LEE'S SUMMIT
MISSOURI
Development Services Department

Development Services Staff Report

File Number	PL2024-073
File Name	PRELIMINARY DEVELOPMENT PLAN – Cobey Creek
Applicant	Clayton Properties Group
Location	500 SE M 150 Hwy
Planning Commission Date	May 23, 2024
Heard by	Planning Commission and City Council
Analyst	C. Shannon McGuire, Planning Manager

Figure 6 – Proposed housing type site plan

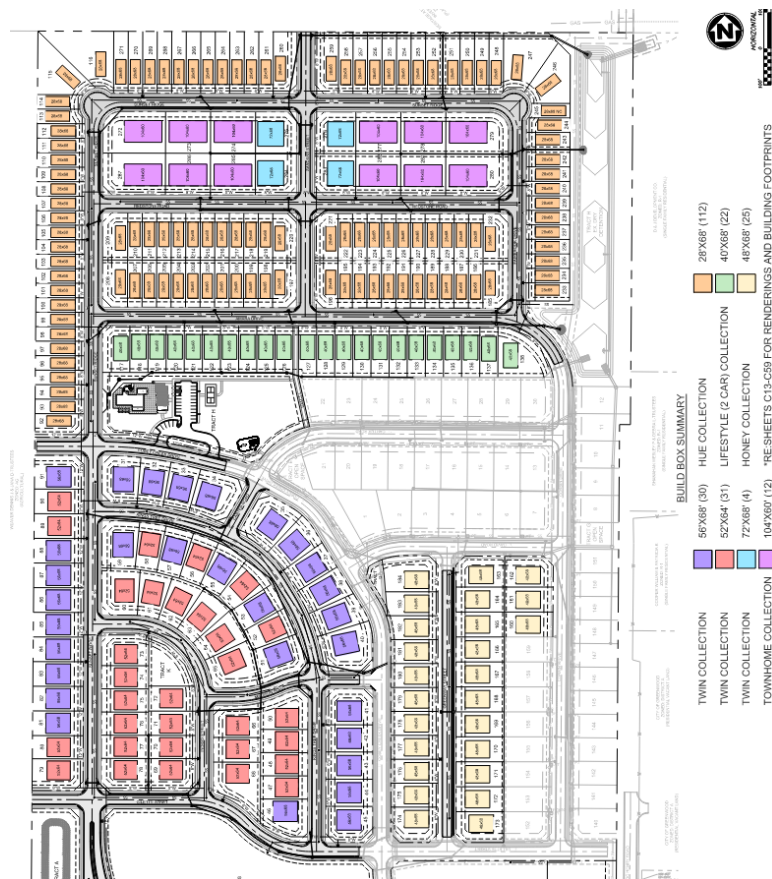
The proposed narrower lots and quadplexes are situated so that they are all located in the northern portion of the development. The layout of the proposed duplexes are in the same general location as the duplexes that were previously approved. The proposed layout provides a stepped approach from the lower density single-family and duplex products to the higher density narrow lot single-family and quad plex products being offered.
